Access Compliance Report

Public Rights-of-Way

(Curb Ramps)

Intersection ID: 19822	Main Street: CHITAL_RD	Cross Street: THORNFIELD_RD	Location: SE
ADA ID: 7CEB9BE02B0C	Ramp Type: BlendTrans1	Initial Pass/Fail: Pass	Overall Compliance: No
		Severity Score: 10

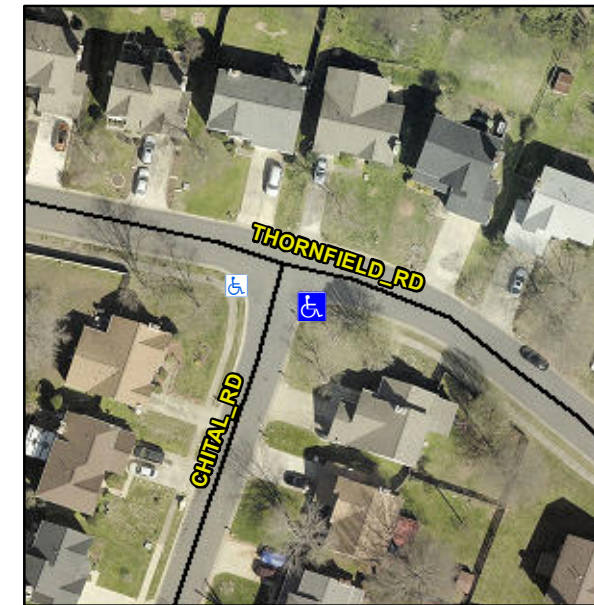
Not Found, R304.2.1, R305

Compliance	Description	Data	Compliance	Description	Data
N/A	Ramp Length (in)	42.0	Yes	BlendTrans Slope (%)	4.2
Yes	Ramp Width (in)	52.0	Yes	BlendTrans XSlope (%)	0.0
N/A	Flare Type LT	Sloped	N/A	Flare Type RT	Sloped
N/A	Flare Slope LT (%)	1.8	N/A	Flare Slope RT (%)	3.5
N/A	Flare Traversable LT?	No	N/A	Flare Traversable RT?	No
No	Landing Length (in)	43.0	No	DWS Provided?	No
Yes	Landing Width (in)	48.0	N/A	DWS Contrast?	No
Yes	Landing Slope (%)	1.1	N/A	DWS Length (in)	N/A
Yes	Landing X Slope (%)	0.8	N/A	DWS Full Width?	No
N/A	Landing Curb? (Y/N)	No	N/A	DWS Offset (in)	N/A
N/A	Shared Landing?	No			
Yes	Gutter Ponding?	No	Yes	Gutter Slope (%)	1.5
Yes	Gutter Lip Ht (in)	0.0	Yes	Gutter X Slope (%)	0.9
N/A	Painted X Walk1?	No	N/A	Painted X Walk2?	No
	X Walk 1 Direction	To N		X Walk 2 Direction	To W
	X Walk 1 Width (in)	N/A		X Walk 2 Width (in)	N/A
	X Walk 1 Slope (%)	6.4		X Walk 2 Slope (%)	7.0
	X Walk 1 X Slope (%)	5.2		X Walk 2 X Slope (%)	1.7

N/A	Ramp inside XWalk1?	N/A	N/A	Ramp inside XWalk2?	N/A
	Road Slope (%)	0.1		Clear Space?	Yes
	Road X Slope (%)	7.9	N/A	Clear Space to XWalk (in)	N/A
Yes	Any Obstructions?	No	Yes	Storm Grate/Utility Hazard?	No
	Obstruction Type			Storm Grate/Utility Type	
		N/A			N/A
			Yes	Surface Condition? (G/P)	Good
			No	Curb Slope (%)	15.1

Remove & Replace Curb Ramp With Two New Directional Ramps or Equivalent.
